**RE: Expedited Settlement Agreement, Number ES-160317-1  
Star Ranch Filing 2 / CDPS Permit Number: COR03M988**

### EXPEDITED SETTLEMENT AGREEMENT

**Stormwater Inspection Report  
Star Ranch Filing 2**

**Photograph 13:** Unnamed road looking north. Disturbed area contributing to photographs 8 - 11.

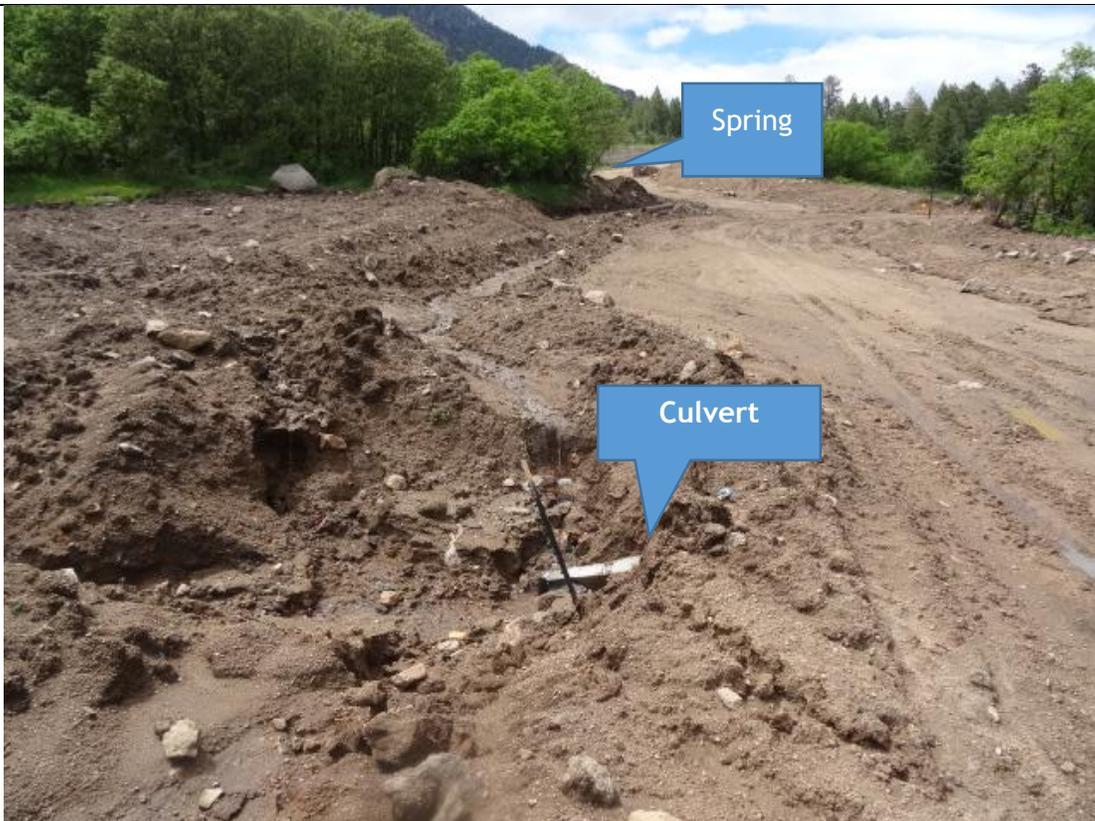
4. It was noted during the inspection that control measures were not implemented to manage stormwater runoff from sediment from disturbed areas located project wide (with the exception of the entrance) (refer to photographs 11, 12, 14, 18, 21, 24 - 30, 32 - 36, 39, 40, 46 - 49).

- Control measures must be implemented to manage stormwater runoff from all potential pollutant sources.
5. It was noted during the inspection that inadequate control measures were implemented to manage stormwater runoff from run-on flows originating in the west side of the project and conveyed to the east approximately through the center of the project area (refer to photographs 15, 16, 19, 37 & 38).
